### REMARKS

### VERSION WITH MARKINGS TO SHOW CHANGES MADE

Fig. 5a (Prior Art)

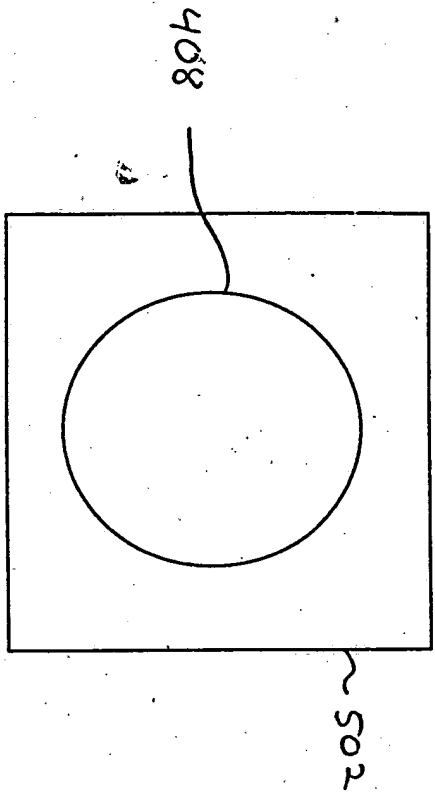
The Office Action has objected Figures 5a-5c under MPEP §608.02(g) for missing a legend such as "Prior Art". In response, the applicants have included red-lined drawings showing corrections to Figures 5a-5c.
